Oakbank Accessibility Action Plan April 2023

4.1 - ACTION TABLE

13.11

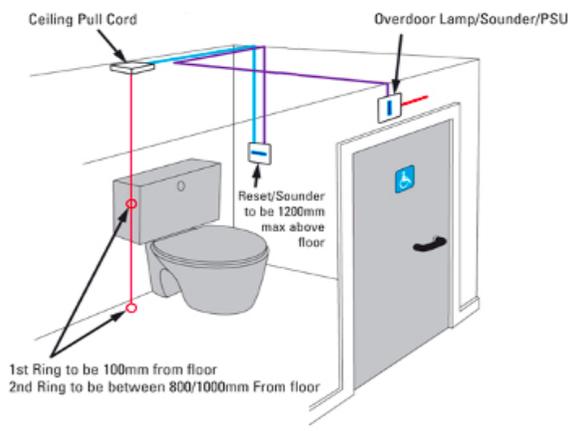
Many of the facilities featured suitably positioned cord alarms.

Tied cord alarms were identified by S44, 830 and 638.

The cord alarm in the sports building facility was positioned on the shelf.

The cord alarm in the CTMC building was high from ground floor level and a reset button was not identified.

Implement a management procedure to ensure that cord alarms are always kept loose and not tied up.

☒
According to BS8300 - An emergency assistance pull cord should be sited so that it can be operated from the WC and from an adjacent floor area. The emergency assistance pull cord, coloured red, should be provided with two red bangles of 50 mm diameter, one set at a height between 800 mm and 1000 mm and the other set at 100 mm above floor level.

Pull cords will be checked and repairs/adjustments carried out.

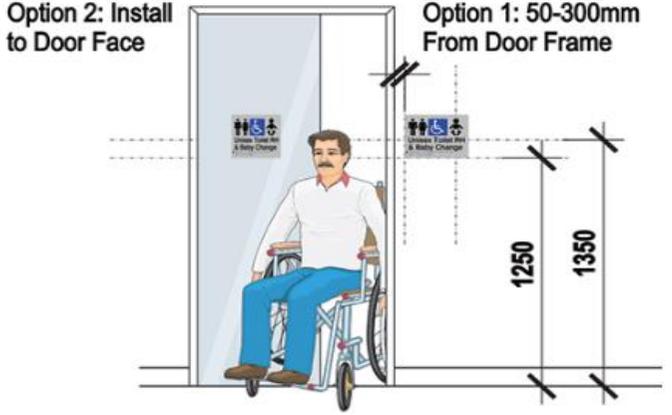
5.6	<p>Powered doors were provided. No issues to report.</p> <p>The proximity reader identified on the Year 8 entrance was not clearly visible from the frame.</p>	<p>For easy identification, all door opening furniture should contrast visually with the surface of the door. A finish should be present that can achieve a minimum of 30 points Irv (Light Reflectance Value) between the system and the surroundings. This could be achieved by providing a contrasted band around the proximity reader systems.</p>	M

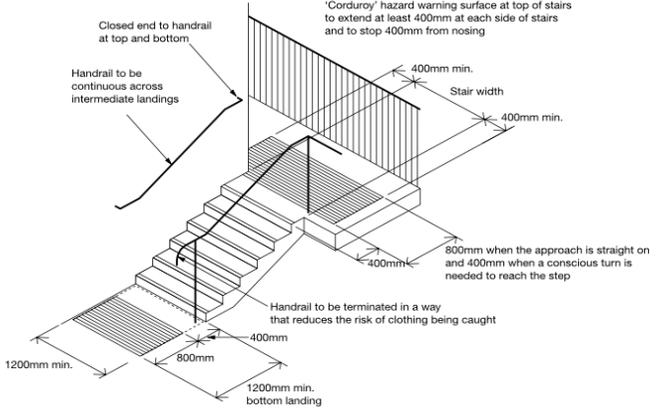
<p>12.4</p>	<p>The lock was slightly broken on the female, staff facility on the second floor.</p> <p>Student WC facilities did not have contrasting cubicle doors as they were the same colour as the frames. This could be confusing for people who are partially sighted.</p>	<p>Site management to schedule maintenance and repair of the lock for the staff, female facility on the first floor.</p> <p>Cubicle doors throughout should appropriately colour contrasted to identify doors within frames to aid people with impaired vision. A difference of 30 points LRV (Light Reflectance Value) is recommended as appropriate contrast.</p> 	<p>M</p>	
<p>12.5</p>	<p>Of the urinals identified, contrast was not provided to assist people who are partially sighted.</p> <p>Grab rails were not identified that could assist people with ambulant disabilities.</p>	<p>The surface finish of sanitary fittings and sanitary-ware, such as urinals, sinks and toilets, should contrast visually with background wall and floor finishes. An LRV (Light Reflectance Value) difference of 30 points is considered good contrast.</p> <p>A well contrasted grab rail should be provided to both sides of one urinal in every WC where applicable.</p>	<p>M</p>
